## Global Change Notification (GCN)

| Product Family | LGA Sockets | 10691334 |

| Series | 105142 | June 24, 2015 |

Before change

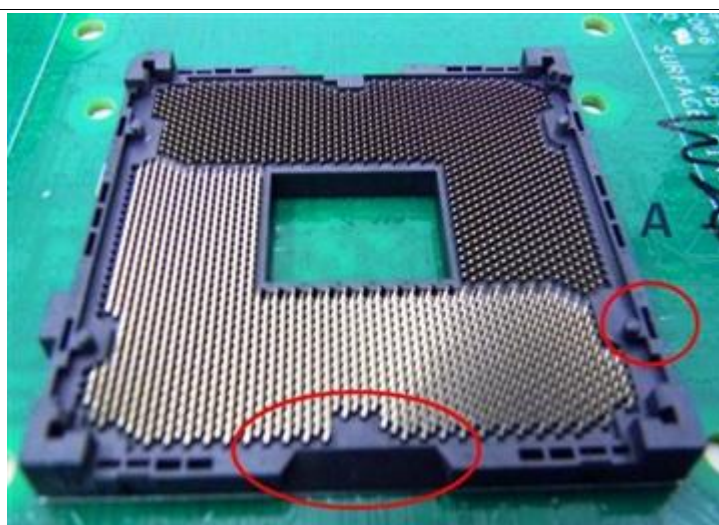
| Change Description | This is to specially inform valued cusotmer as requested of the change to LGA Sockets to Modify housing core outs and finger relief to reflect the "test probes" cut outs and finger relief shown on Intel drawings. The changes does not affect the form, fit and function of the product .This change was made so that our parts are visually similar to Intel drawings. the change had implemented in wk24,2014 and it was running change and no special reminding needed. |
